Commonwealth Edison  
One First National Plaza, Chicago, Illinois  
Address Reply to: Post Office Box 767  
Chicago, Illinois 60690

November 21, 1977

Subject: Dresden Station Unit 2  
Proposed Amendment to Appendix A,  
Technical Specifications, for Facility  
Operating License No. DPR-19 to  
Support Reload No. 3  
NRC Docket No. 50-237

EB2CR806LR150 EOC6-1500  
100% PWR-100% FLOW

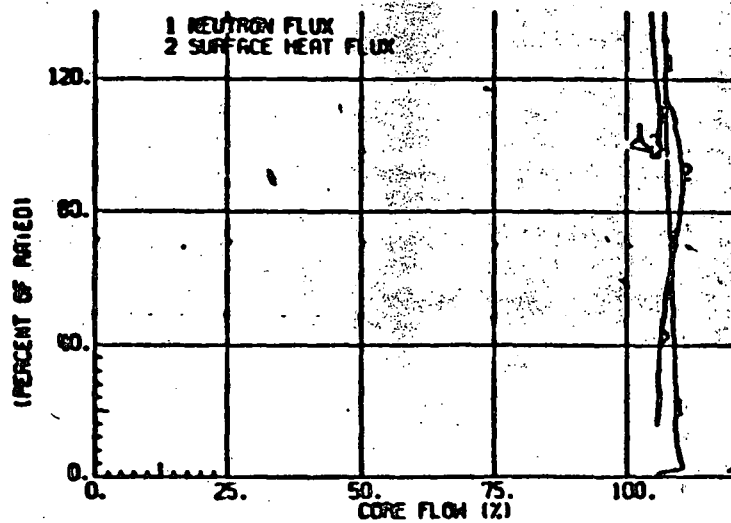
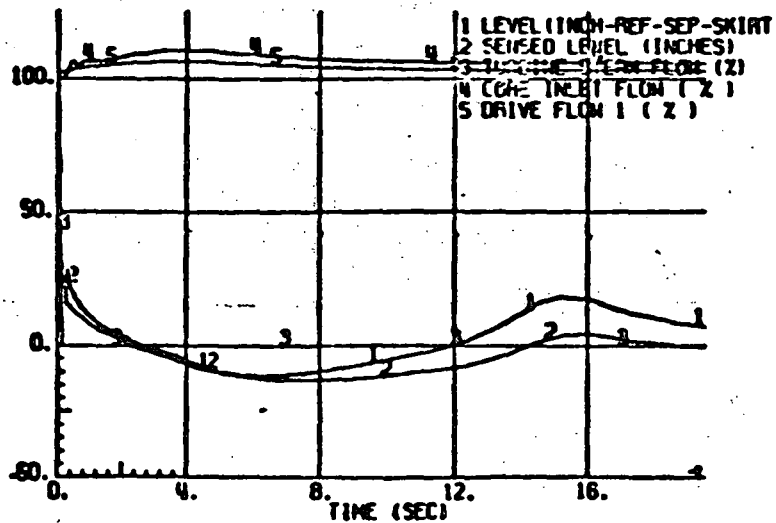
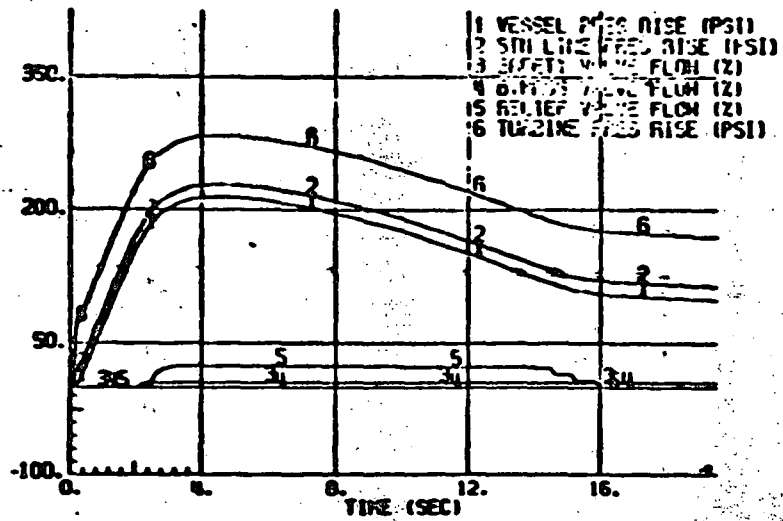
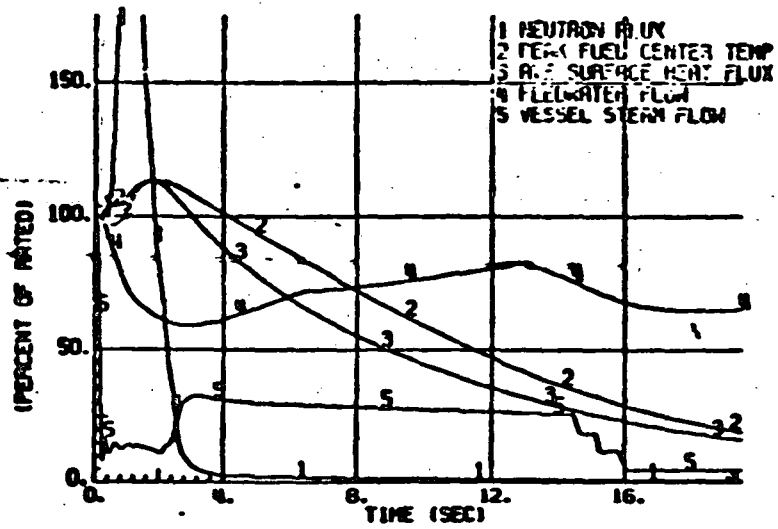
A transient reevaluation was performed which resulted in a different limiting pressure transient (Load Rejection without Bypass) than that presented in NEDO-24034 (Turbine Trip without Bypass) transmitted by Reference (a). In addition, an input error in the Turbine Trip without Bypass analysis of NEDO-24034 was located. The new analyses are summarized in Attachment I to this letter. The resulting  $\Delta$ CPR's for 8 x 8 fuel are: 1) old Turbine Trip transient (0.21), 2) new Turbine Trip transient (0.18), and 3) new Generator Load Rejection transient (0.20). The Rod Withdrawal Error remains the limiting  $\Delta$ CPR for 7 x 7 fuel.

Figure 1 - Dresden 2 Fuel Type Map

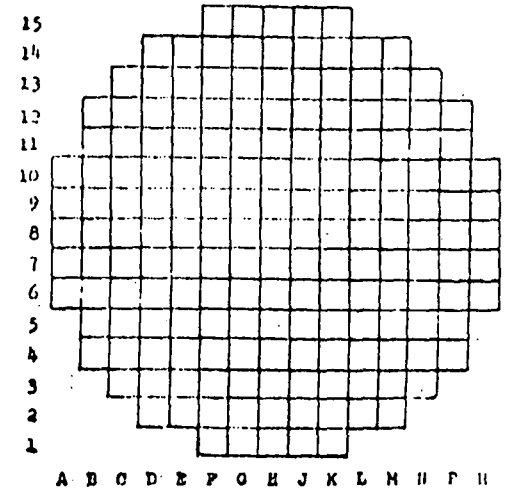
The Unit 2 core configuration has been changed from that described in NEDO-24034. The revised fuel type map is shown in Attachment II. The revised core configuration has been evaluated for the Fuel Bundle Loading Error and has been found to be more severe. The new analysis results for the re-shuffled core are presented below.

The worst case misplaced bundle is the misplacement of a fresh 8 x 8 bundle in an exposed 8 x 8 bundle location. Starting from an initial MCPR of 1.26, the resulting MCPR is 0.98. Consequently, the initial MCPR will be raised to 1.34. The maximum LHGR of the misplaced bundle is 17.8 kw/ft.

The misplacement of a fresh 8 x 8 bundle in a 7 x 7 location has not been affected (1.17 MCPR).

The rotated bundle is a fresh 8 x 8 bundle. Starting from an initial MCPR of 1.26, the resulting MCPR is 1.10. The maximum LHGR is 16.1 kw/ft.
